Subject: Duane Arnold Energy Center
Docket No. 50-331
Operating License DPR-49
Reporting of Changes to the Quality Assurance Program
Description, UFSAR 17.2

This letter transmits three changes to Revision 16 of the IES Utilities Inc. Quality Assurance Program Description (QAPD) for the Duane Arnold Energy Center in accordance with the requirements of 10 CFR Section 50.54(a)(3). These three changes were previously provided by references 2 and 3 and have now been revised to incorporate the results of reference 4. In addition, responsibility for the resolution of conflicts on quality matters have been added in response to concerns expressed by the reviewer.

Mark-up of USFAR section 13.1,
"Conduct of Operations"

Figure 13.1-1

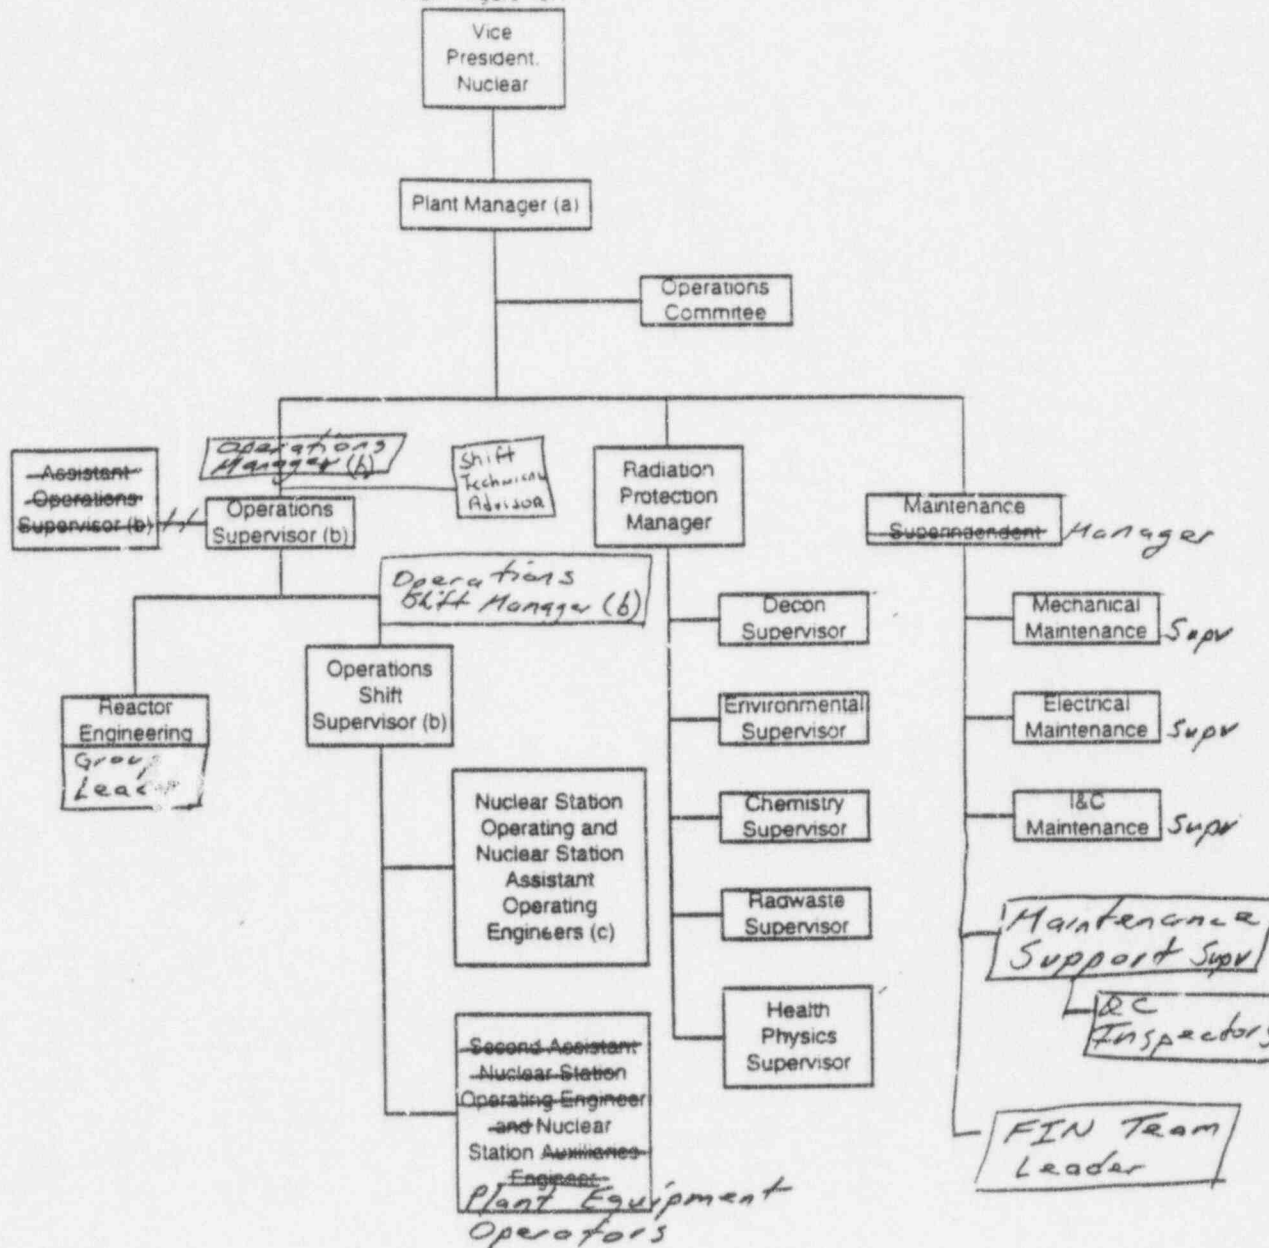
and
The Vice President, Nuclear reports to the President, ~~Chief Operating and Chief Financial Officer.~~ The Nuclear Generation Division Organization is shown in Figure 13.1-1.

The Manager, Corporate Quality Assurance, is assigned the primary responsibility for ensuring that quality requirements relative to the safe operation of the DAEC are identified and met. He reports to the ~~Vice President, Nuclear~~. (See Figure 13.1-1).
